| <i>Locality</i> | Keku Islands, N. W. |

DESCRIPTIVE REPORT - DATA RECORD
T - 12184

REVIEW REPORT T-12184

ADDENDUM TO REVIEW REPORTS

T-12/84

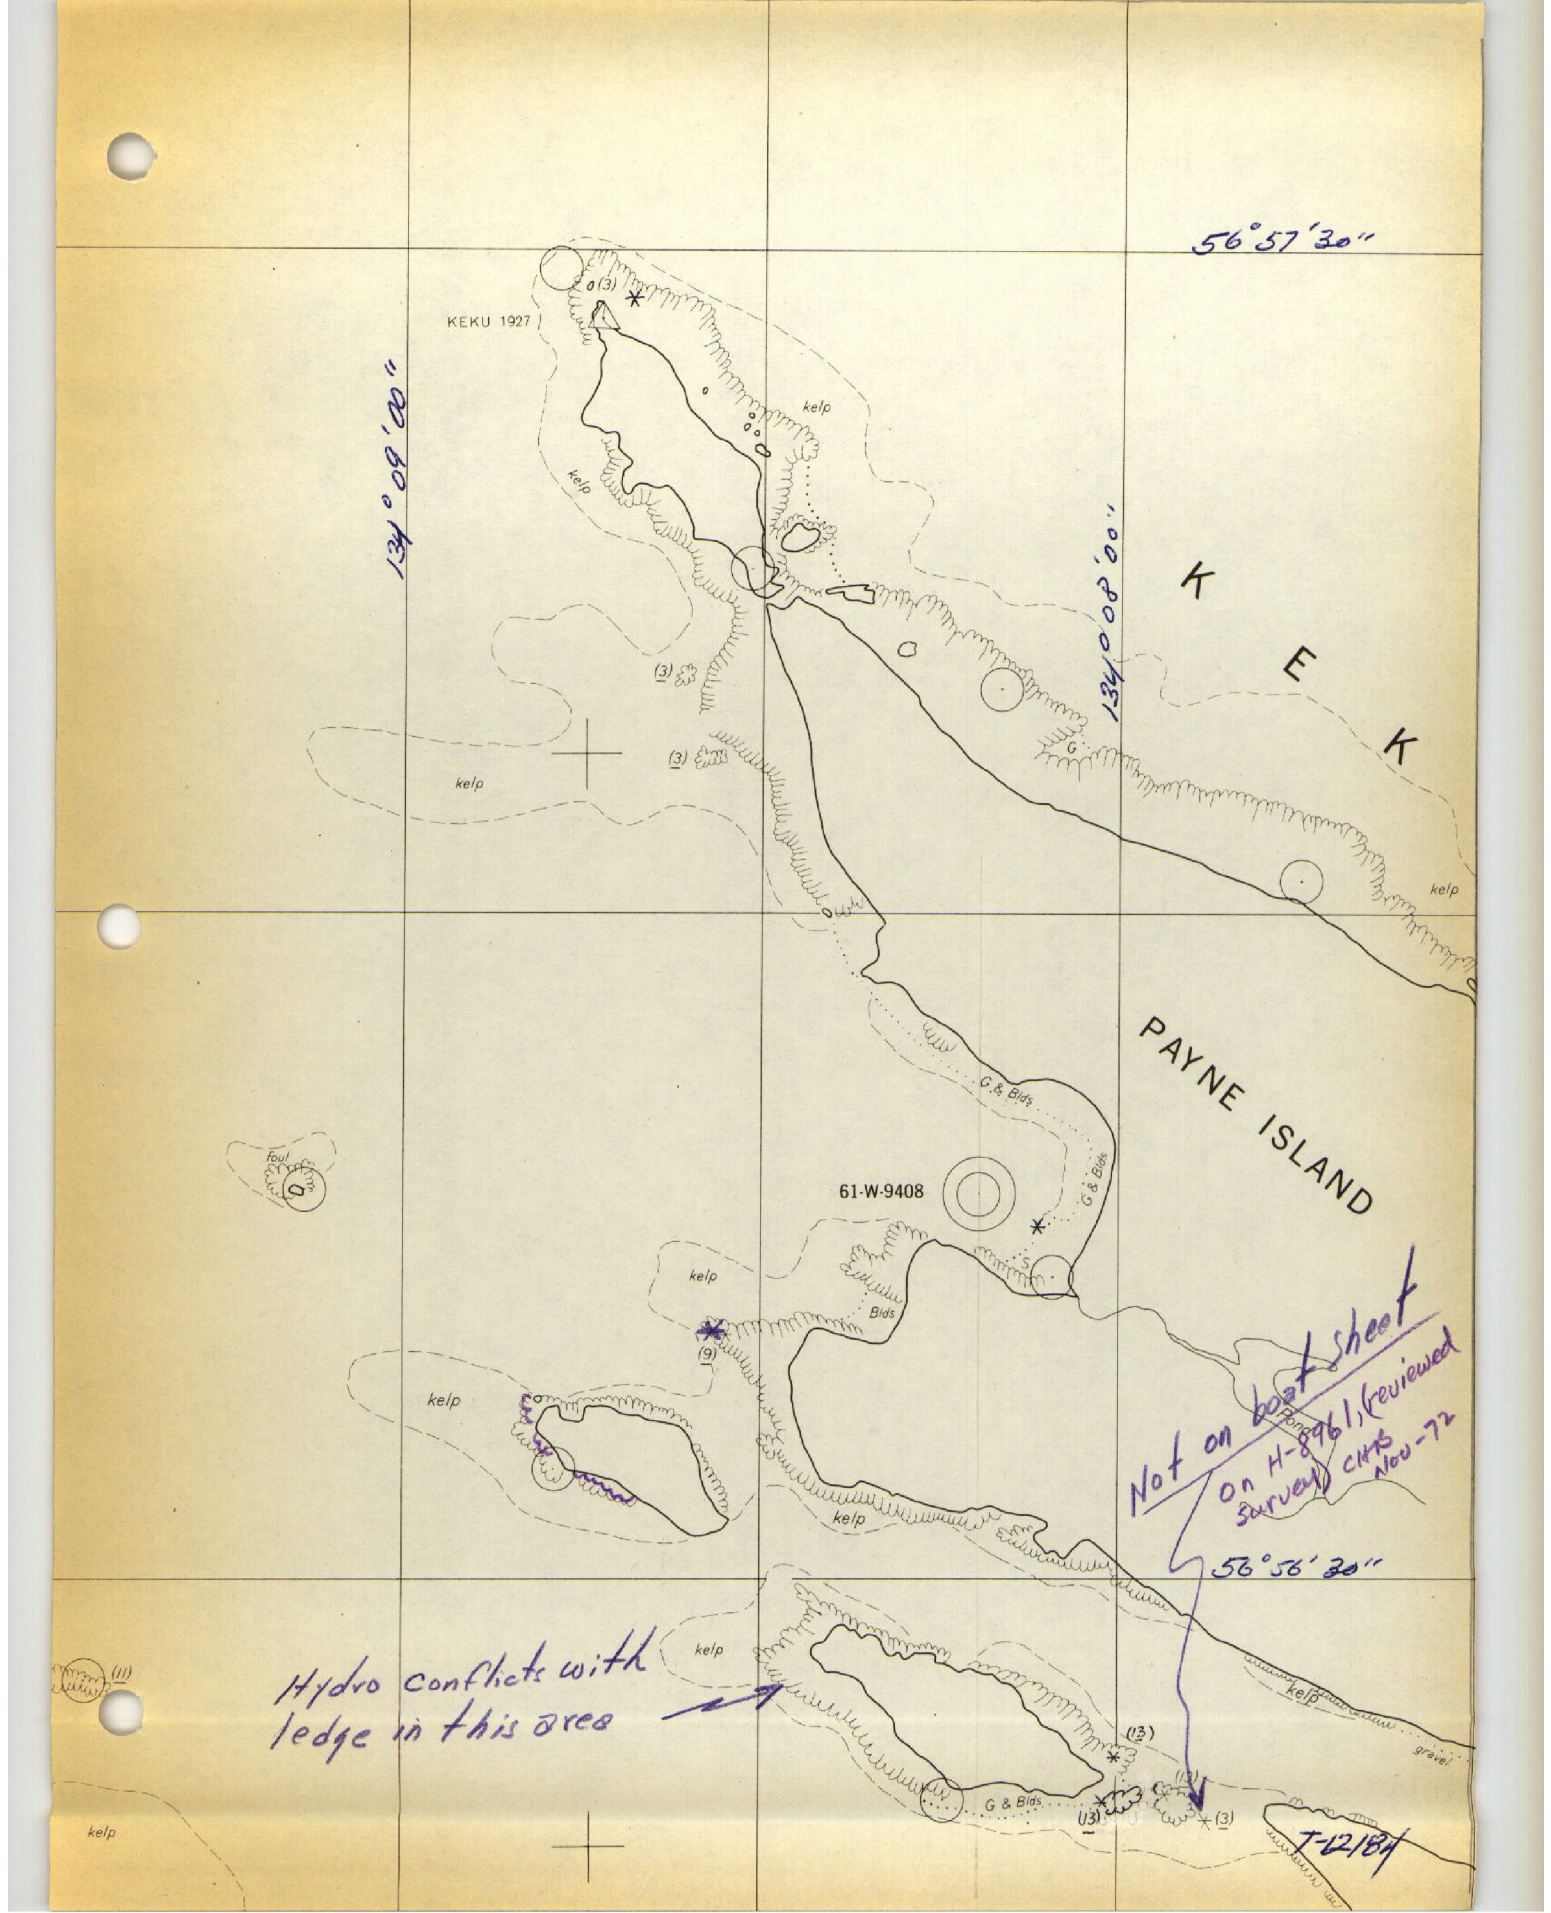
Not on boat sheet
on H-8961 (reviewed
survey) CHS
Nov-72

Hydro conflicts with
ledge in this area

Rocks on boat sheet from incomplete manuscript. Not found by Field editor.

Special attention is called to two rocks on the boat sheets, one located at latitude $56^{\circ}56'27''$ longitude $134^{\circ}06'36''$ and the other at $56^{\circ}56'20''$ - $134^{\circ}05'45''$. The source of these rocks was the incomplete manuscript. They were not found by the field editor nor were they verified by the hydrographer. They were removed from T-12184 by the final reviewer as they were probably patches of kelp instead of rocks.

Some soundings of the boat sheets plot on the ledges which surround the islands in this survey. These ledges are clearly visible on the photographs of the area and appear to be correctly compiled on the manuscript.
